UNITED STATES PATENT AND TRADEMARK OFFICE

APPLICATION NO.	FILING DATE	FIRST NAMED INVENTOR	ATTORNEY DOCKET NO.	CONFIRMATION NO.
09/665,899	09/20/2000	Masayoshi Iwase	10517/74	6300

Office Action Summary

DETAILED ACTION

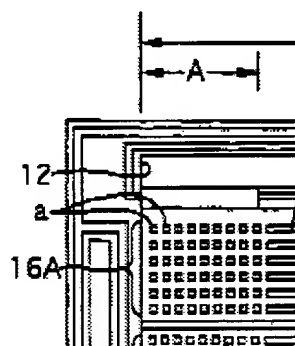
supply inlet which connects the fluid passage and supplies a gas to the fluid passage therethrough, wherein the gas supply inlet is located so that a gas flow between the gas supply inlet and the fluid passage is parallel to a gas flow in the fluid passage". In view thereof, Applicant submits that the claimed invention allows for gas "flowing from passage 305 directly onto surface 311 in the direction of flow across the joint body, *i.e.*, without having to immediately turn to begin flowing down the gas flow path". (Applicant's response, page 5) In reply, however, the examiner submits that the scope of the present claims does not preclude the gas supply inlet to result in the gas flow to "immediately turn" prior to flowing down the fluid passage. Further, the scope of the present claims does not recite *the extent* to which the gas flow between the inlet and the passage is parallel to flow of gas within the passage itself. [emphasis added] It appears to the examiner that Applicant intends to claim the substantially linear flow of gas between hole [305] and hole [306] such as illustrated in Figure 6, prior to the gas flow making a turn such as indicated by the arrows. However, absent of more clarifying language, in Kurita the gas flow between the inlet [12] and the passage is asserted parallel to the flow of gas within the passage itself such as at least within passage areas [16a], [17b] or [17d], since the scope of the present claims does not require the gas flow to traverse the entire length of the separator plate.

As to new independent claims 20 and 24, the rejection of record is similarly applied in addition to the following. The plurality of regions [16a], [17b], [17d] communicate with each other in that the regions are contiguous with respect to the gas flow passages formed therein. As to a regular pattern across the width of each region, it is asserted that a regular pattern of, e.g., six [a] projections or six [b] rib portions are present within each region. As to a regular pattern

across the length of each region, it is asserted that a regular pattern of nine [a] projections at both ends of each region with an intervening rib portion [b] disposed parallel to its length is present.

First turning passage:

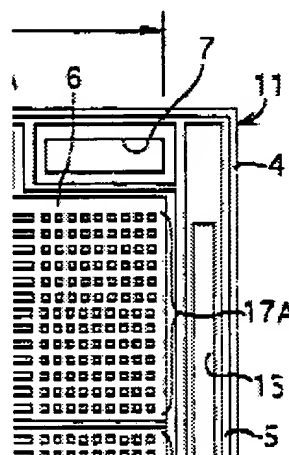
As to claims 22 and 26 which recite a width of a turning passage between the end of the rib portion and an opposing peripheral wall of the separator, to the extent that the claims are understood by the examiner for the reasons discussed under 35 U.S.C. 112, second paragraph (discussion above), the width of the starting end of the rib projection [16a] when measured from this rib portion end and an opposing peripheral wall is less than the width of the immediately upstream region. For clarification, enhanced portions of the turning passages are herein shown:

Second turning passage:
